PROPOSAL

The applicant proposes to remove two attic windows and install two new windows in the existing openings.

APPLICATION FOR HISTORIC AREA WORK PERMIT

Aeris Aeris 1000 Series 1001 - Double Hung

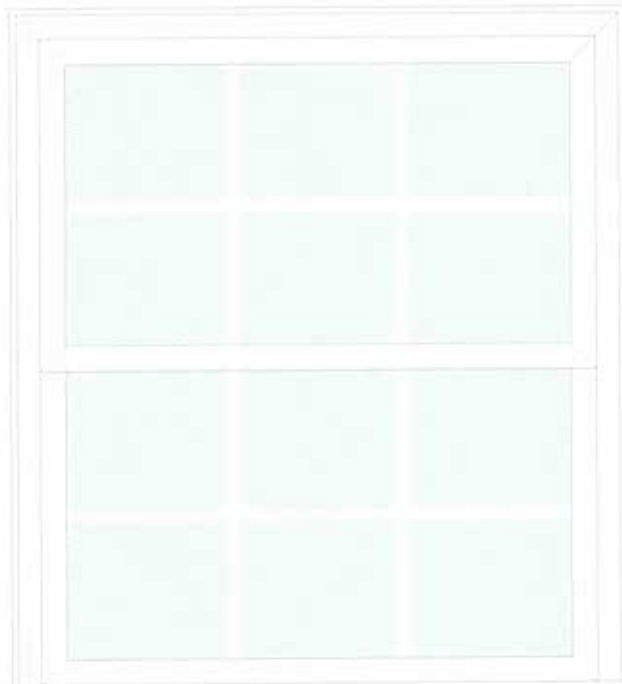
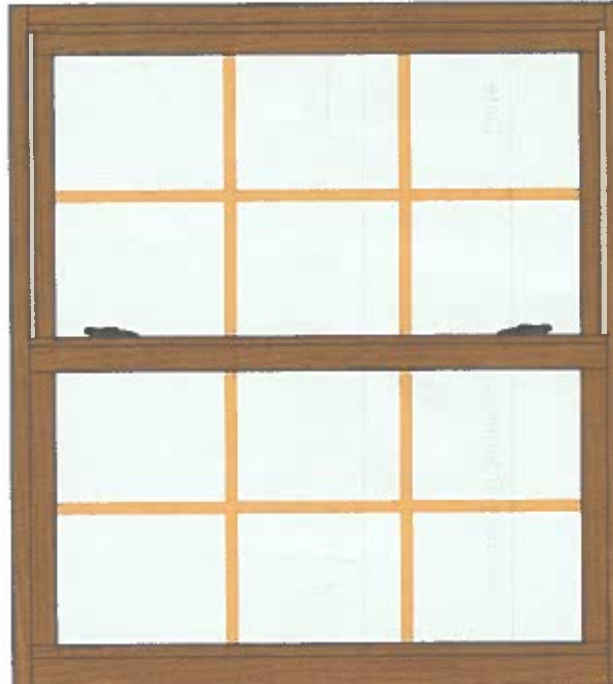
The preferred window materials for a replacement window in the Takoma Park Historic District are wood or aluminum clad wood because those materials best replicate the profile of a historic wood window. Vinyl windows are generally disfavored because they tend to have a flatter profile and a shinier appearance that does not dull over time. In this instance, the applicant proposes to install a vinyl-clad SDL window. Staff finds the 7/8" (seven-eighths inch) exterior and interior grids will help to add some depth to the window and create a more compatible profile. Without examining a sample window, Staff cannot provide feedback on the character of the exterior finish, but Staff finds the finish is less important in this instance. First, Staff finds the proposed replacement window is on a side-facing dormer, that is much less visible from the public right-of-way than the front-facing dormer. Second, Staff finds there is a benefit to having the attic windows match, even though the right-side dormer is not as visible as the front-facing one. An incongruent window appearance in the attic may stand out and attract attention, rather than reinforcing the existing patterns, per the *Design Guidelines* and 24A-8(d). But for the front window replacement in-kind, Staff would not recommend the HPC approve the proposed vinyl clad attic window.
